PLANNING AND ZONING COMMISSION MEETING AGENDA

AGENDA REPORT

SUBJECT: PPUD24-0002: Ridley Village Court Planned Unit Development Preliminary Development Plan

Figure 4: Preliminary Improvement Plan

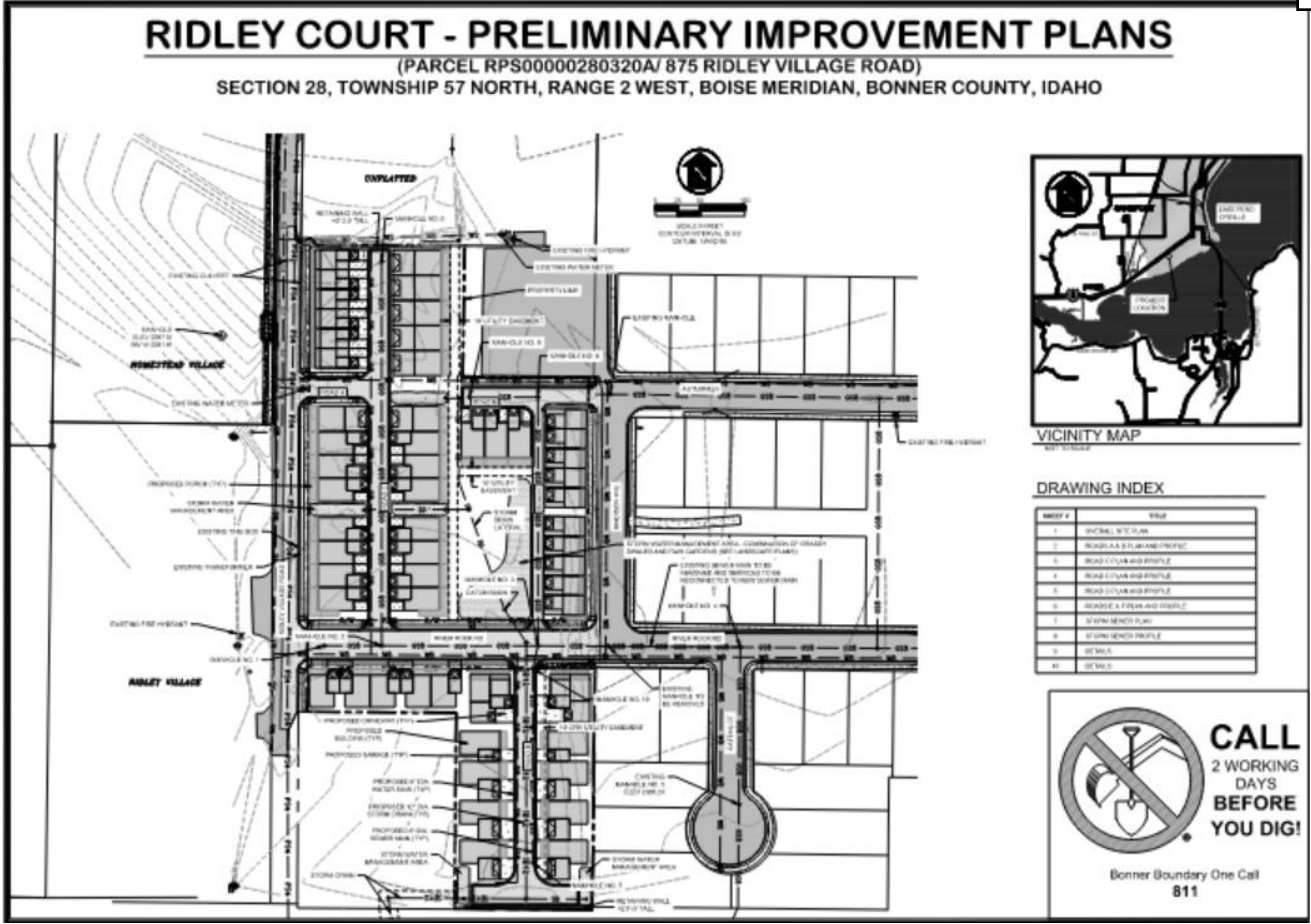
Units fronting Madison Avenue have 1-car garage units that are accessed off of Road E. The proposed width of Road E is dimensioned as 12 feet. The garages are 90 degrees to the private road, and it appears that Road E will be used as the maneuvering area in accordance with SCC 9-5-4. The plan does not dimension the distance between the front of the garages and the edge of Road E, but it appears to vary from 2.25 feet to 4.5 feet. It is not clear if the parking facility meets the dimension standards of 9-5-14.A. The city will need to determine if additional room beyond the 12-foot-wide private road is needed to accommodate the 90-degree parking maneuver (in and out of the 1- car garages). According to the city parking diagram and chart, a 23-foot minimum driveway width (for 1-way and 2-way) is needed for 90-degree parking.

SCC 9-5-12.I requires that areas for snow storage must be designated in site plans and provided for in development or redevelopment of property. The north end of Road C calls for a 3-foot to 3.5-foot-tall retaining wall at the end. Since access to off-street parking seems necessary, the City should review how snow is proposed to be pushed and stored at the north end of Road C and maintain access to the 1-car garage at the end of the street.

Proposed development does not comply. Private north-south driveways do not provide adequate width between buildings to provide the required easement width.

Staff Recommends revising development plan to provide rounded property corners at intersections, complying with all required setbacks.

Townhouse unit at the southeast corner of River Rock and Ridley Village, as shown on the submitted improvement plans, appears not to meet this provision.

Staff Recommends revising the development plan to allow adequate room for water and sewer main extensions.

3. Driveway for the townhouse units at the southeast corner of River Rock and Ridley Village, as shown on the submitted improvement plans, shall be located at least 35 feet from the proposed curb line along Ridley Village Road, pursuant to Sandpoint City Code 10-1-6-F.

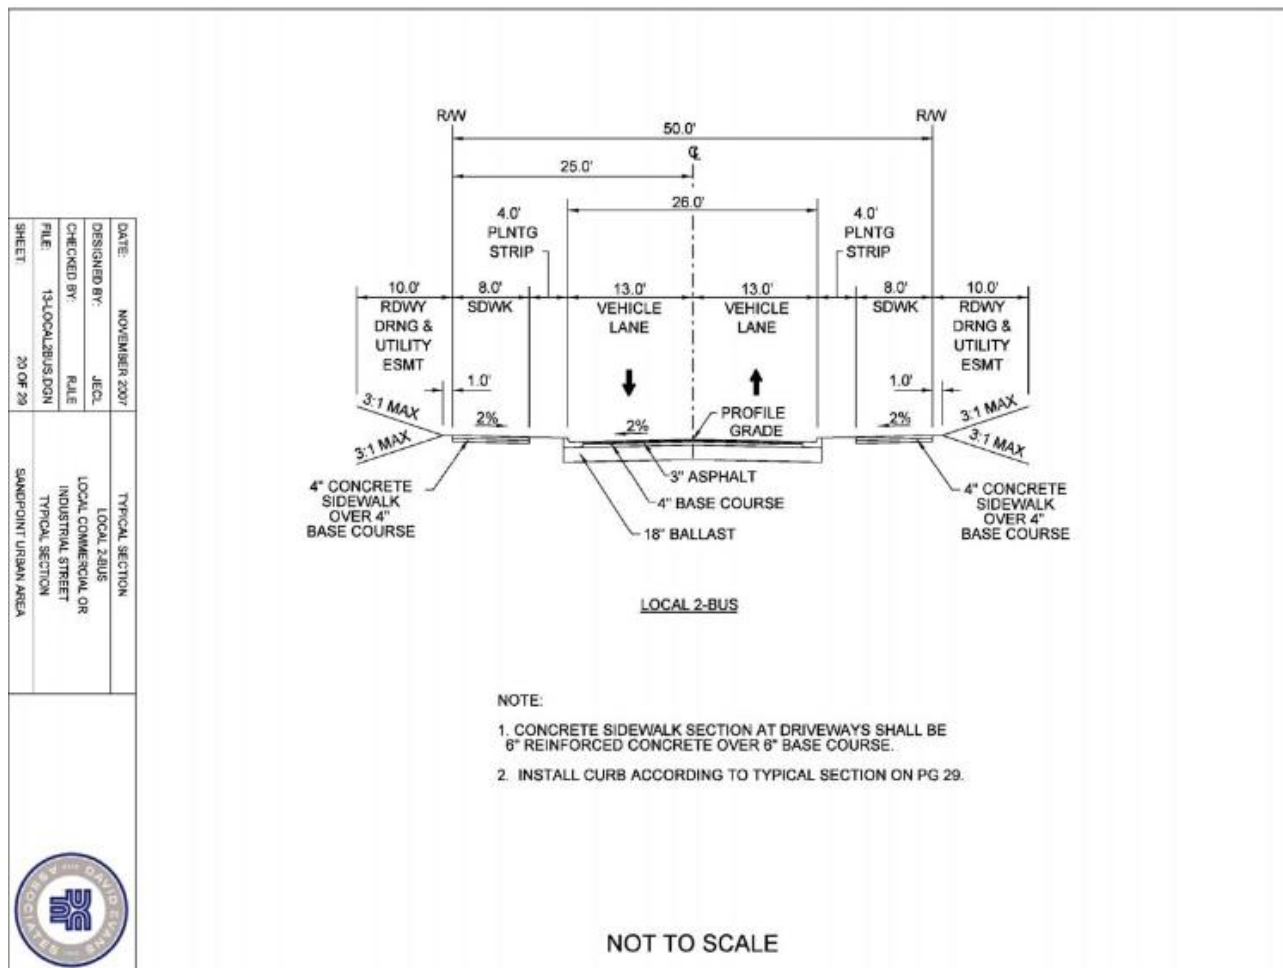
Typical section 4.3 on sheet 9 shows 31-foot pavement width from lip of curb to lip of curb, with 5-foot sidewalks on both sides.

Staff Recommends revising typical section 4.3 on sheet 9 of the improvement plans to show 29-foot pavement width from lip of curb to lip of curb (Two 11-foot travel lanes, one 7 foot parking lane on the north side). Provide “no parking” signs on south side of River Rock. Extension of Autumn Lane should show a similar section.

Alternative recommendation: If directed by the Planning and Zoning Commission and City Council, new streets could accommodate a pavement width of 32 feet, with two 11-foot travel lanes and two 5-foot bike lanes on both sides, with no parking allowed on either side of the street.
